SUPPLEMENTAL FINAL ENVIRONMENTAL
IMPACT STATEMENT

ALBANY PORT DISTRICT COMMISSION
PORT OF ALBANY EXPANSION PROJECT

TOWN OF BETHLEHEM, NEW YORK

Date: February 2022

Employee Trip Assignment

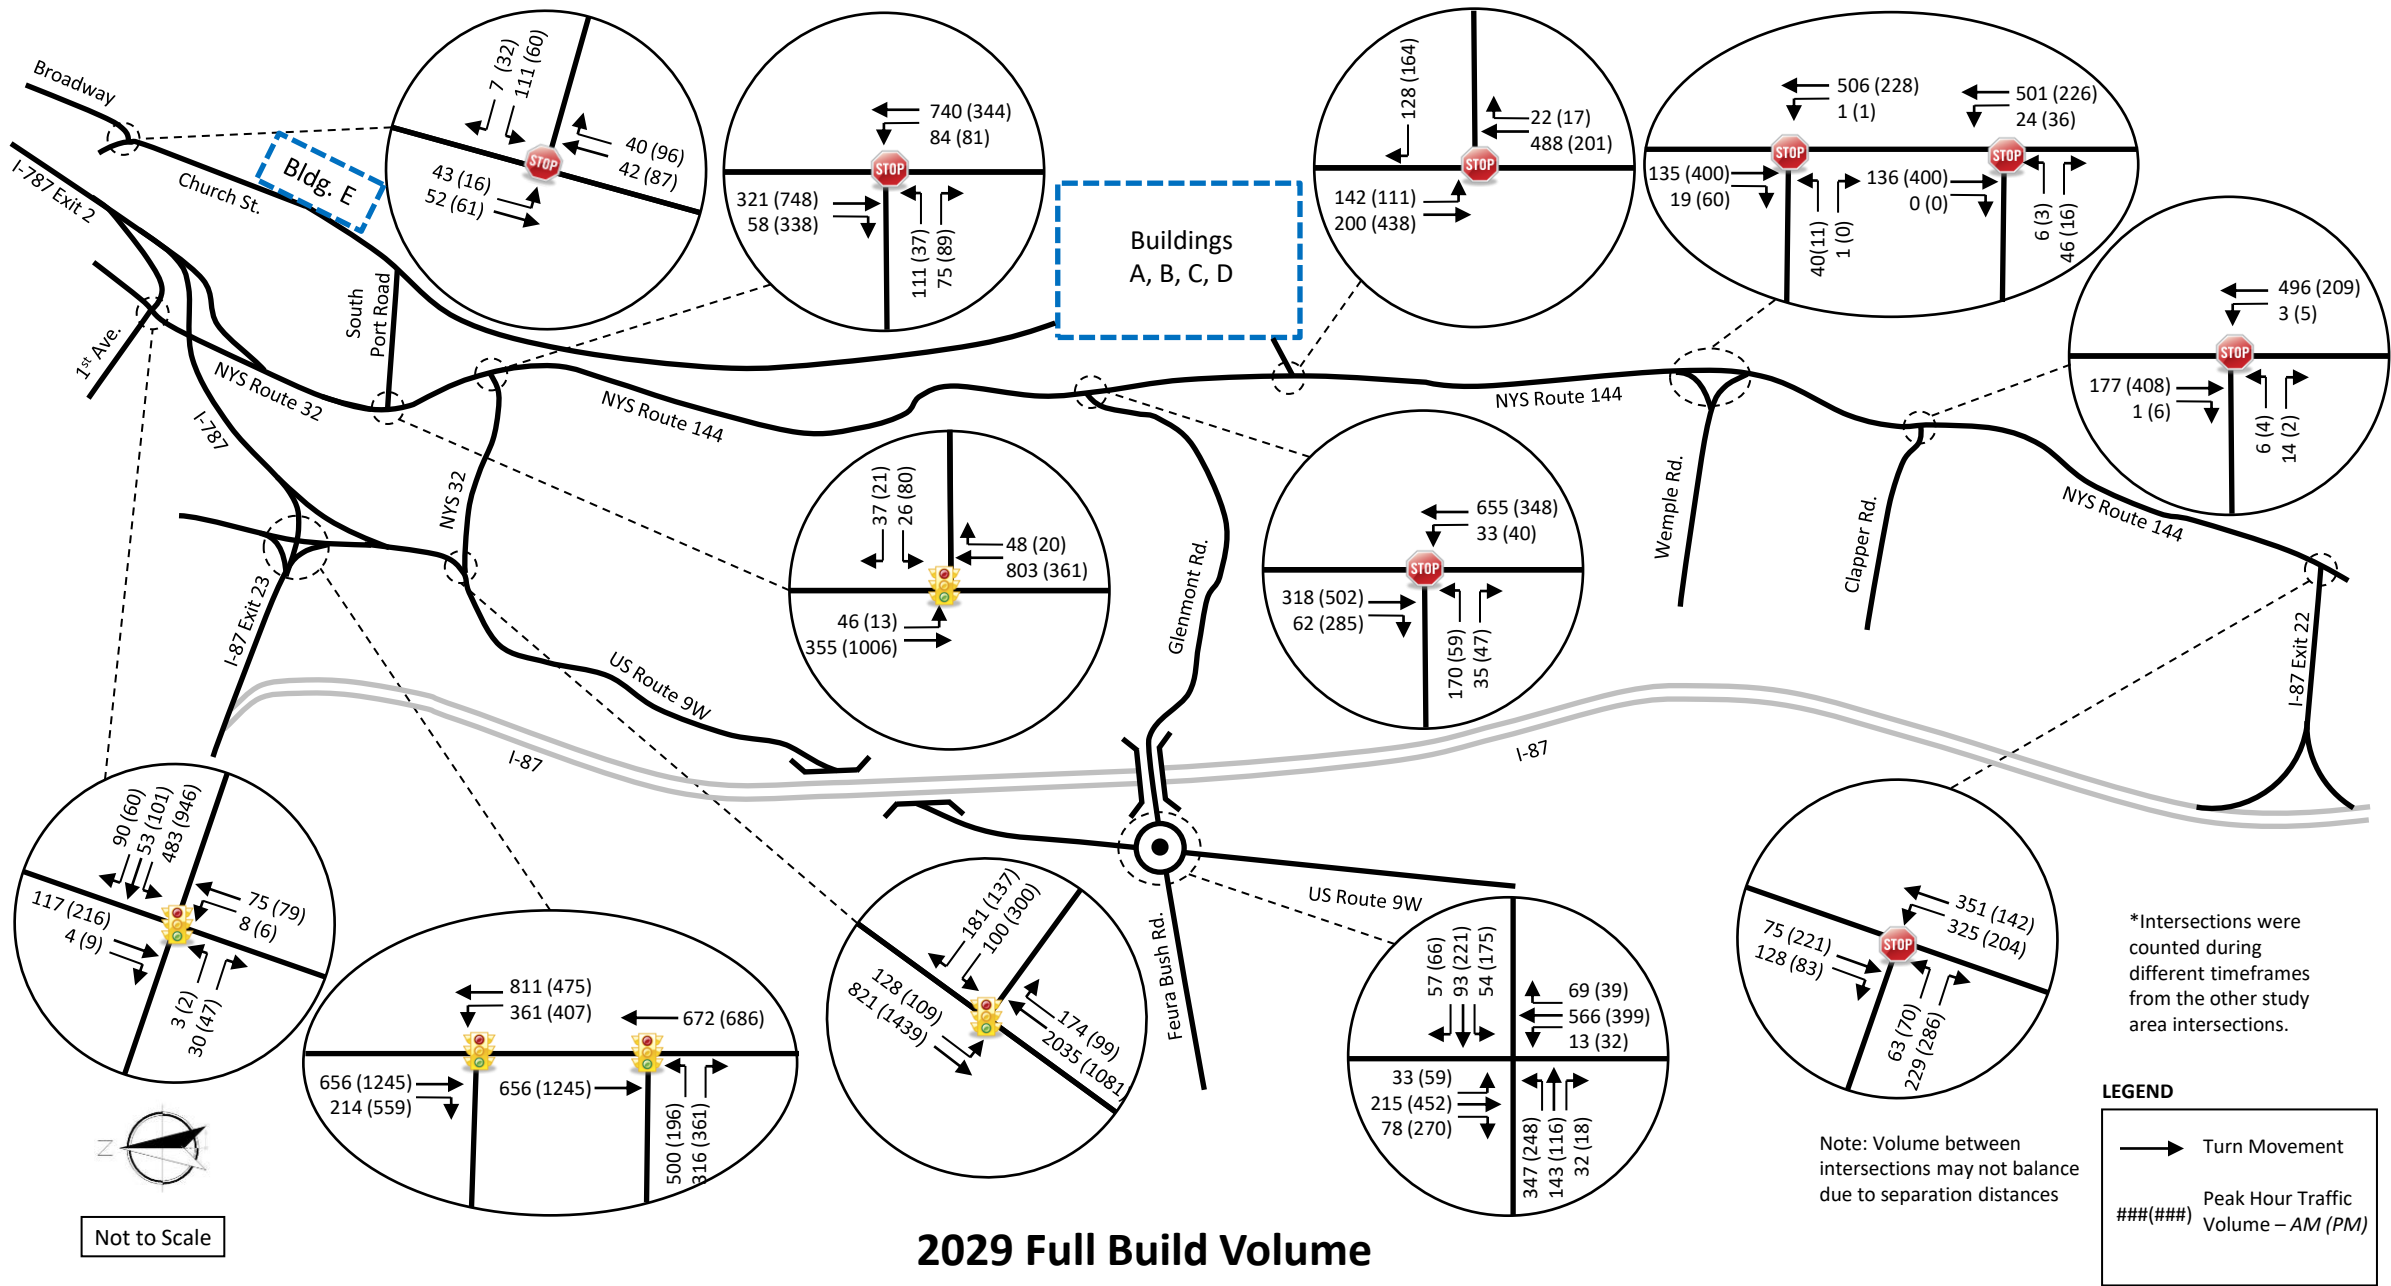
Comment B-9: Page 14, Figure 6: Modify legend to include AM and PM volume designation.

Response: The legend has been modified to clarify the AM and PM volumes shown on Figure 6, which is included in Appendix CC.

Stopping Sight Distance Plan

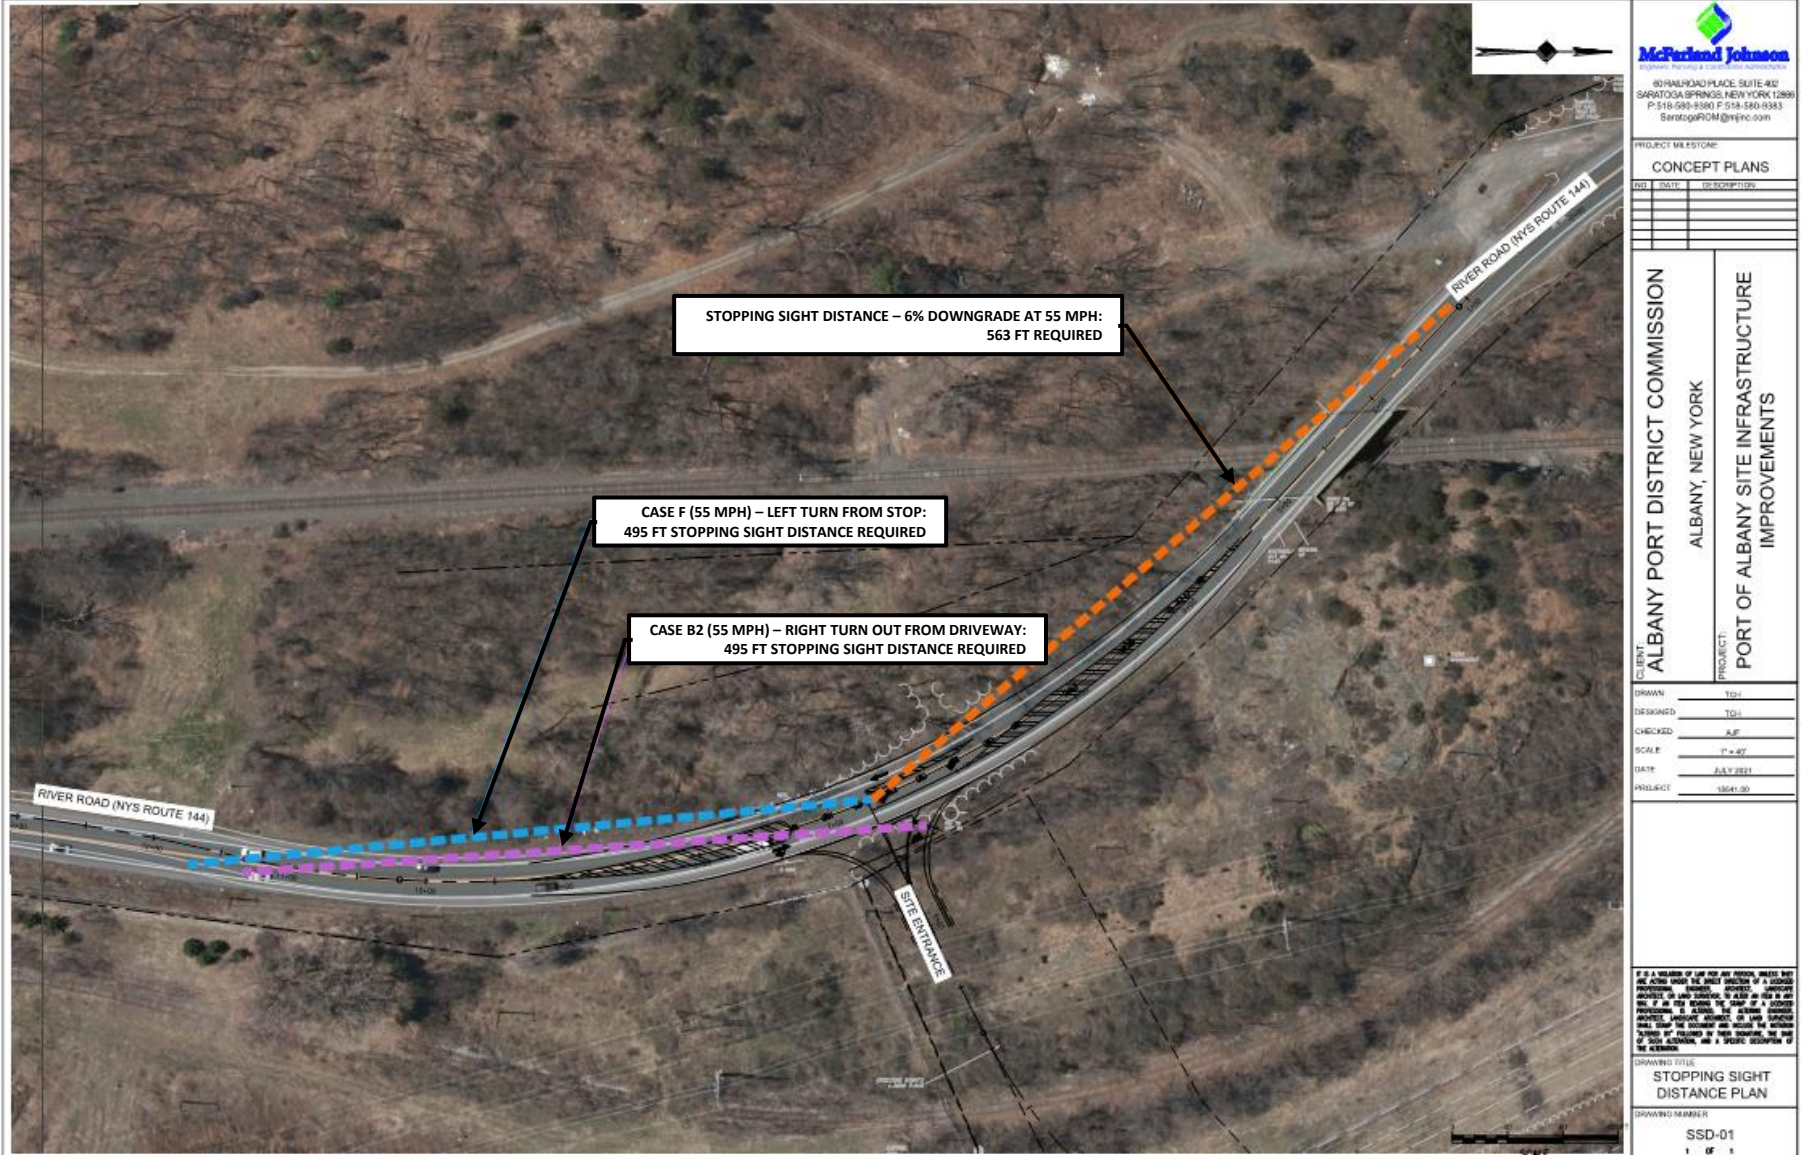
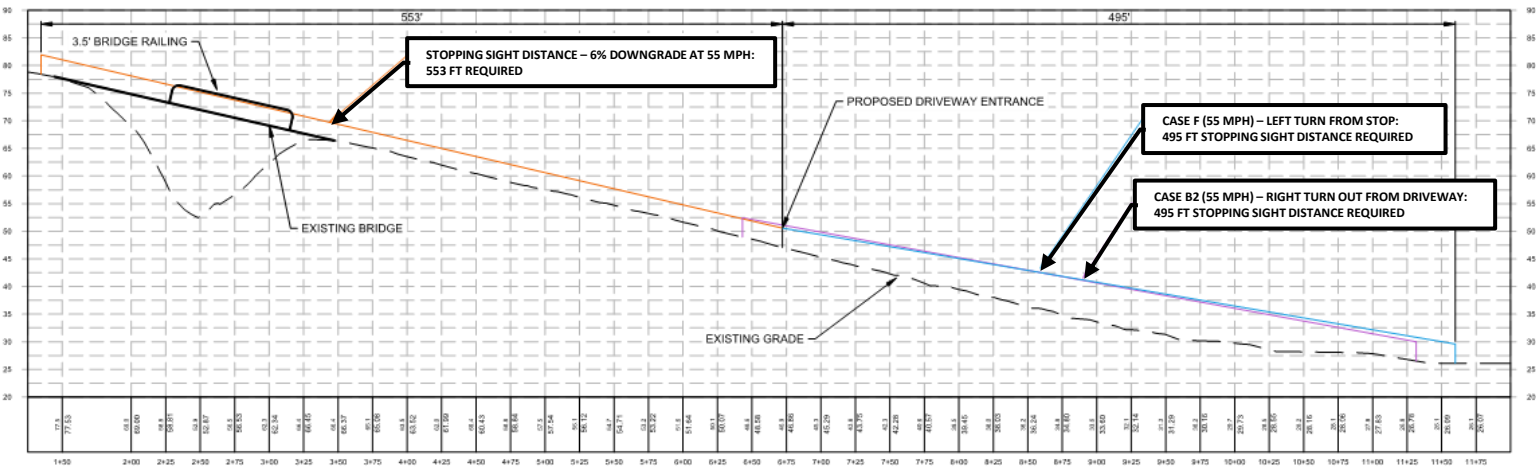
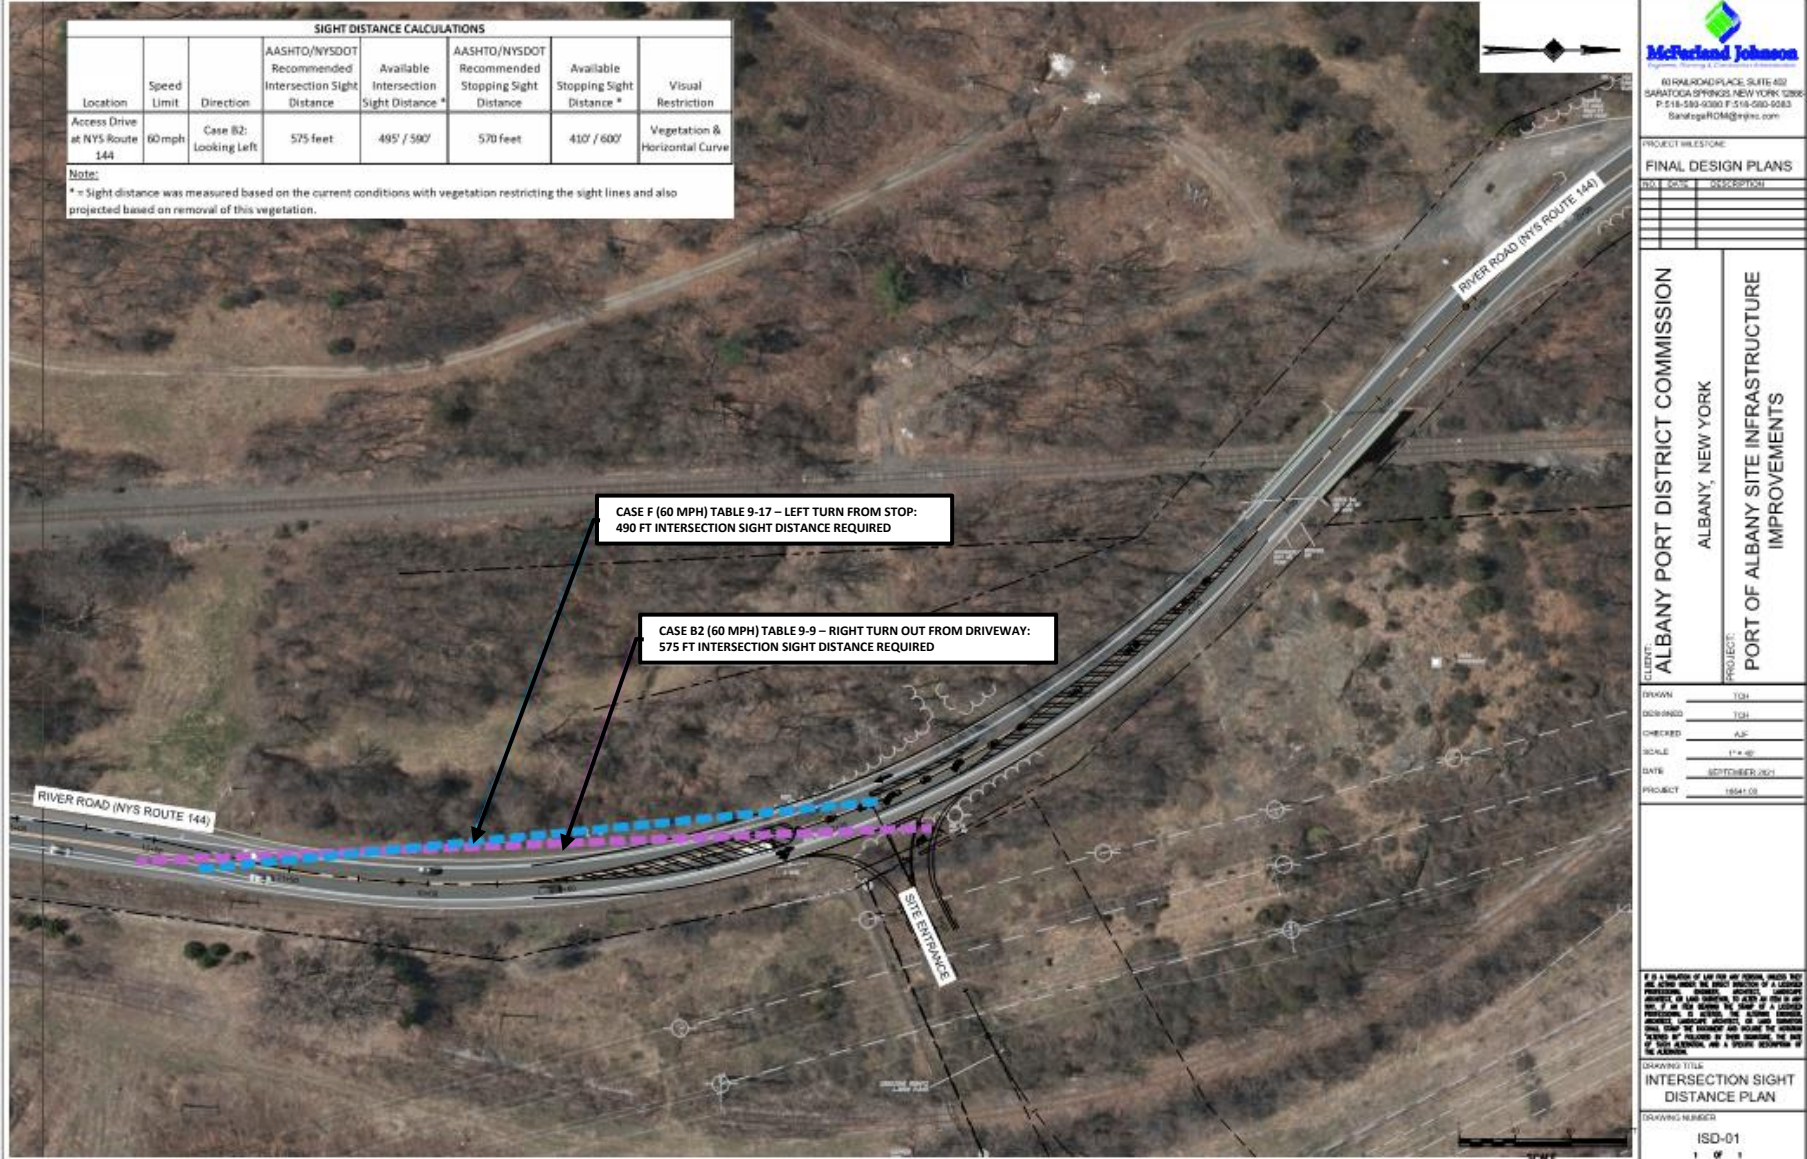
Comment B-18: Page A1-A3, Figures 7A, 7B, and 7C: Provide figures with text that is readable. The text is blurry and difficult to read. Figure 7C uses 60 mph speed compared to 45/55 mph used in other parts of the report. Explain why this is different at this location than other locations in the report.

Response: Provided in Appendix CC are PDFs of the figures which are legible. The 60mph speed that was used on Figure 7C at the request of the NYSDOT which was conveyed during several coordination meetings with their staff. The NYSDOT wanted to ensure that adequate sight distance could be provided with vegetation clearing for the current 85th percentile speed that they measured in the area. The clearing areas on the design plans were also requested to be at a setback of at least 10' back from the proposed sight lines.
